Changes made as a result of the Application Review and Plan Check

902 Foul Bay Road

Revised Rezoning III July 29, 2021

Landscape Revision List

6 Tree Planting Plan

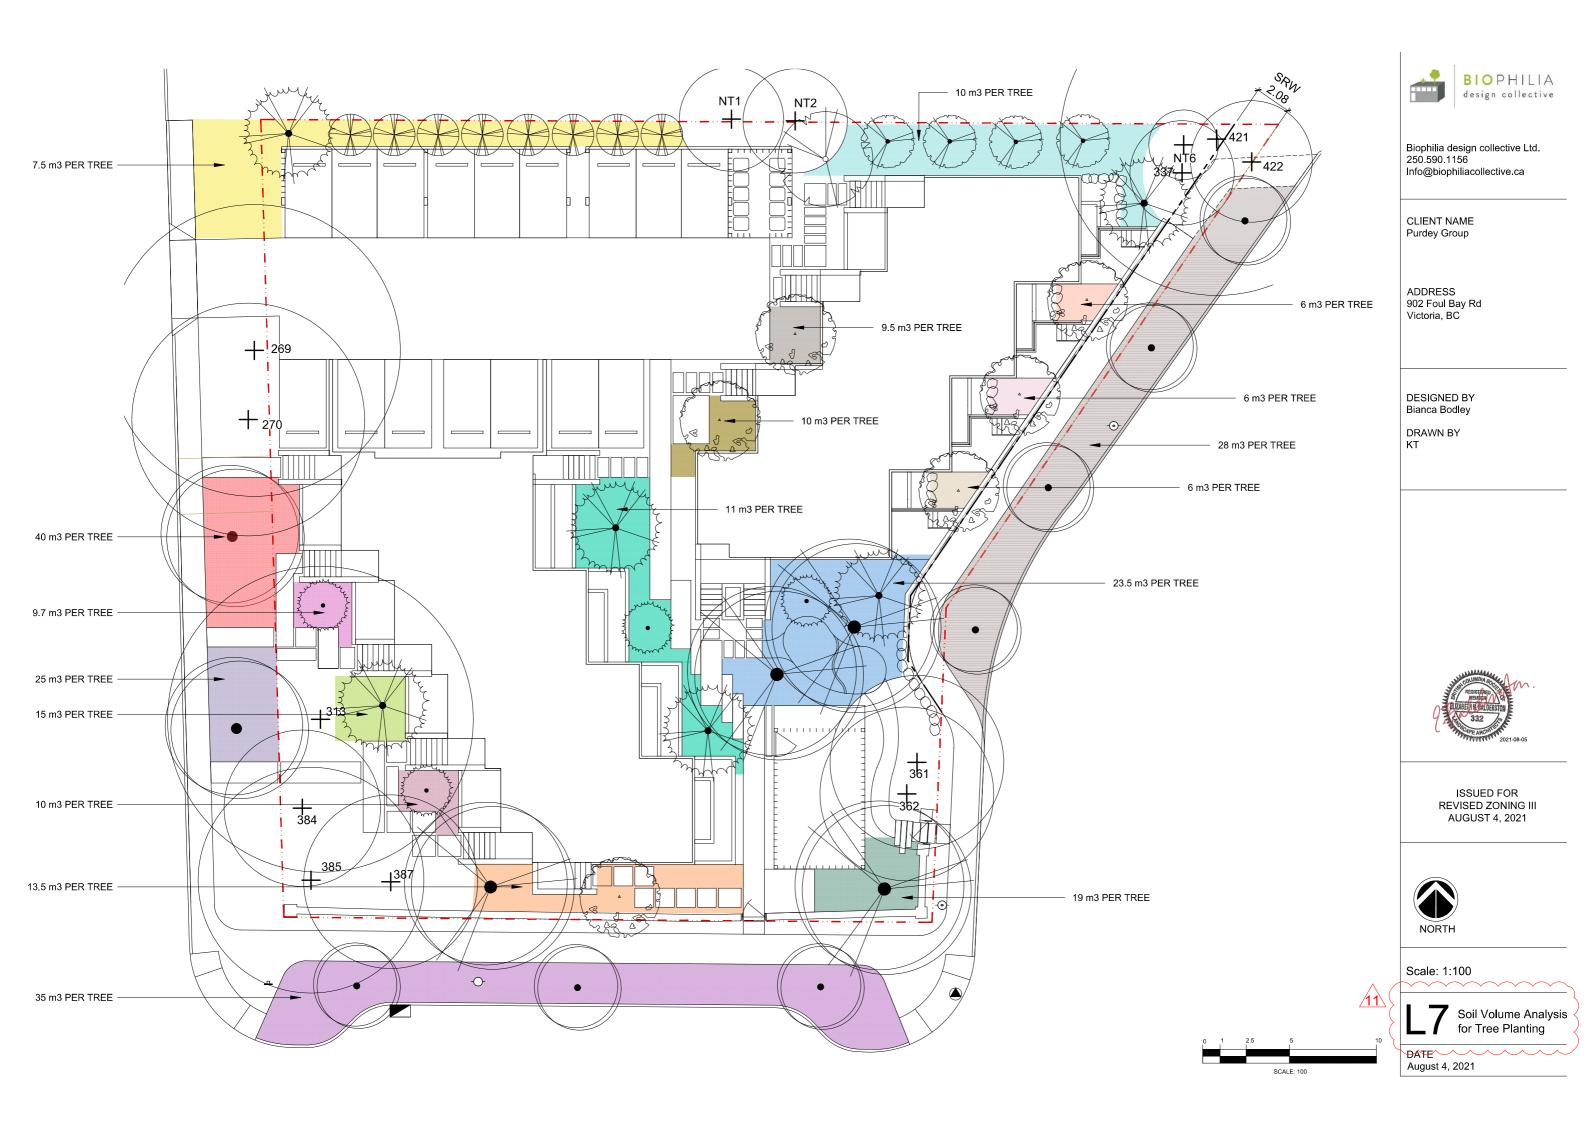
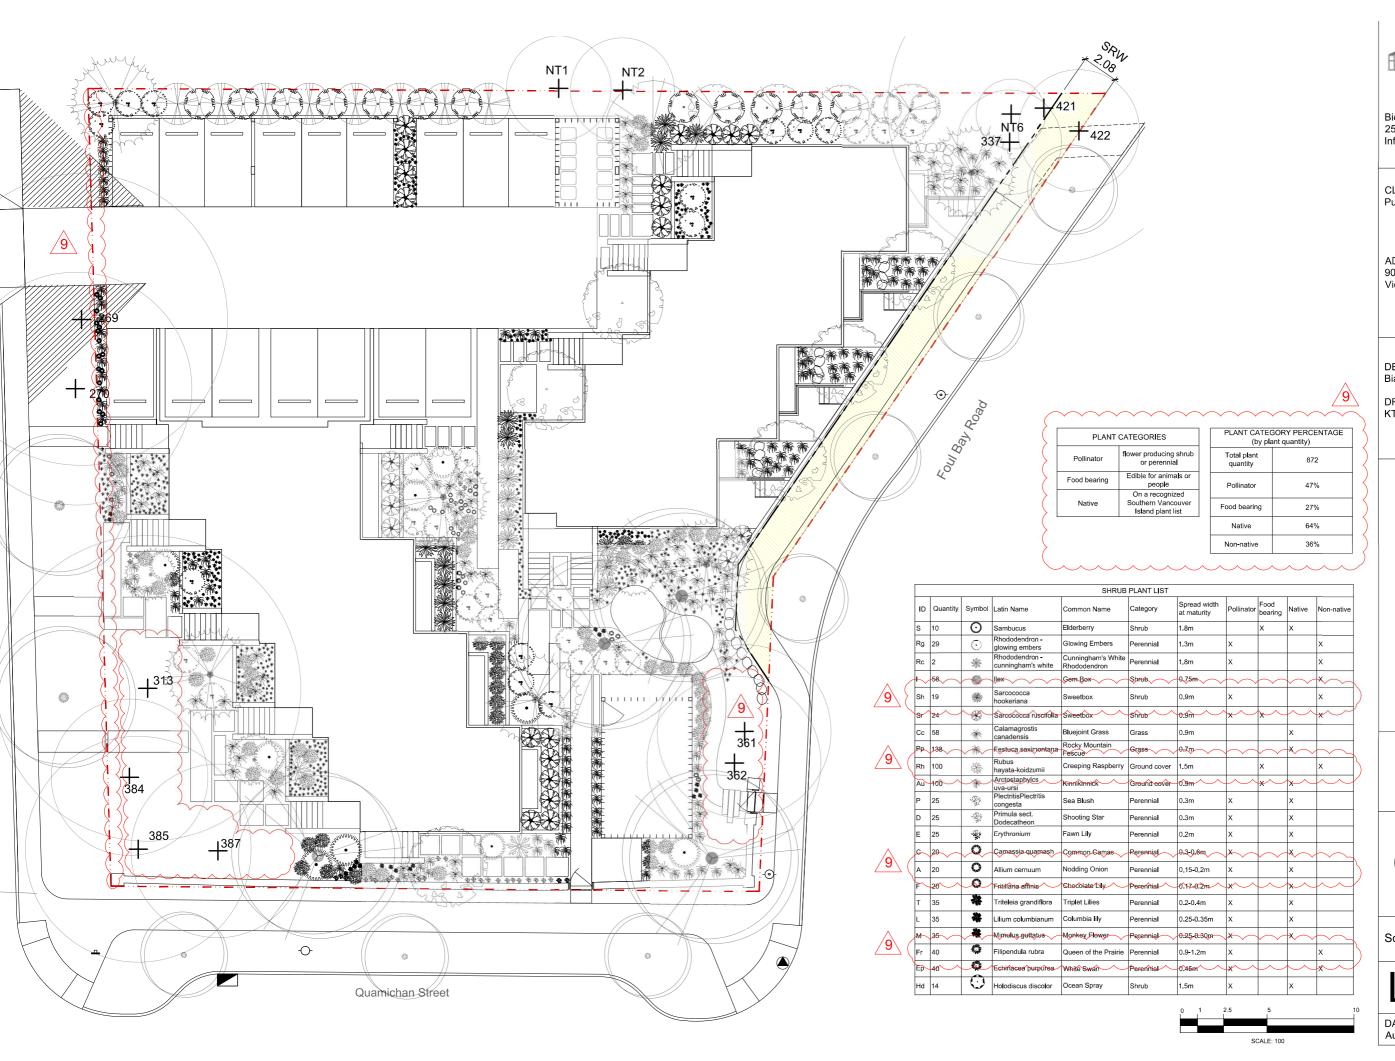
7	Tree Planting	L1, L4	Additional street tree added to Foul Bay frontage Tree planting in general revised in response to site plan changes Replacement trees revised as per City comments Summary of trees to be removed and replacement trees required updated
8	Tree Protection Fencing	L4	See arborist report for tree protection fencing specifications, location and phasing instructions
9	Shrub Planting	L1, L8	 Shrub planting in general revised in response to site plan changes Proposed shrubs removed from underneath existing trees to minimize disturbance to tree roots as per City comments Shrubs removed from within 0.45 m from property line as per City comments (assume groundcovers and perennials are acceptable) Shrub designations updated as per City comments Methodology for percentage analysis noted as per City comments
10	Arborist Report	L5	Arborist tree retention and removal spreadsheet updated
11	Soil Volume	L7	Drawing indicating available soil volume per tree added
